Access Compliance Report

Public Rights-of-Way

Intersection ID: 50341	Main Street: SCONE_PALACE_CT	Cross Street: CASTLECOVE_RD	Location: SE
ADA ID: 712C6E52D11B	Ramp Type: PerpDiag	Initial Pass/Fail: Fail	Overall Compliance: No
Codes/Mitigation Info/Possible Solution		Field Measurements/Component Compliance	
Severity Score: 21.25

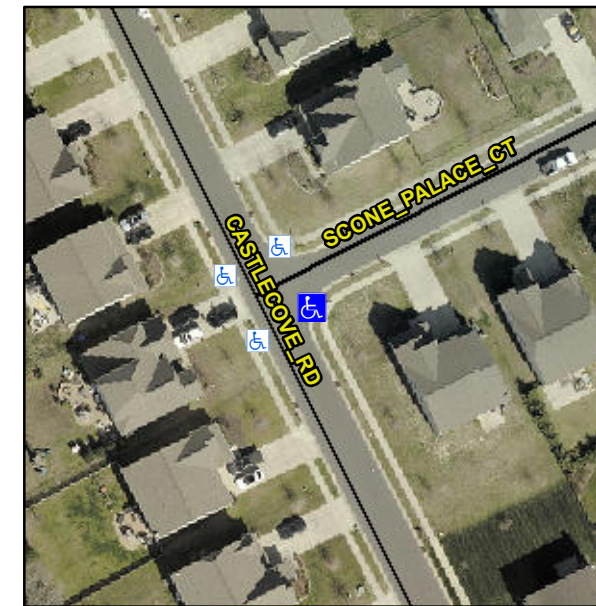
Remove & Replace Curb Ramp With Two New Directional Ramps or Equivalent.

R304.5.1, R304.2.2

Compliance	Description	Data	Compliance	Description	Data
N/A	Ramp Length (in)	47.0	No	Ramp Slope (%)	9.1
No	Ramp Width (in)	47.0	Yes	Ramp XSlope (%)	1.6
N/A	Flare Type LT	N/A	N/A	Flare Type RT	N/A
N/A	Flare Slope LT (%)	N/A	N/A	Flare Slope RT (%)	N/A
N/A	Flare Traversable LT?	N/A	N/A	Flare Traversable RT?	N/A
N/A	Landing Length (in)	N/A	N/A	DWS Provided?	N/A
N/A	Landing Width (in)	N/A	N/A	DWS Contrast?	N/A
N/A	Landing Slope (%)	N/A	N/A	DWS Length (in)	N/A
N/A	Landing X Slope (%)	N/A	N/A	DWS Full Width?	N/A
N/A	Landing Curb? (Y/N)	N/A	N/A	DWS Offset (in)	N/A
N/A	Shared Landing?	N/A			
N/A	Gutter Ponding?	N/A	N/A	Gutter Slope (%)	N/A
N/A	Gutter Lip Ht (in)	N/A	N/A	Gutter X Slope (%)	N/A
N/A	Painted X Walk1?	No	N/A	Painted X Walk2?	No
	X Walk 1 Direction	To NW		X Walk 2 Direction	To SW
N/A	X Walk 1 Width (in)	N/A	N/A	X Walk 2 Width (in)	N/A
	X Walk 1 Slope (%)	1.4		X Walk 2 Slope (%)	4.3
	X Walk 1 X Slope (%)	0.8		X Walk 2 X Slope (%)	2.4
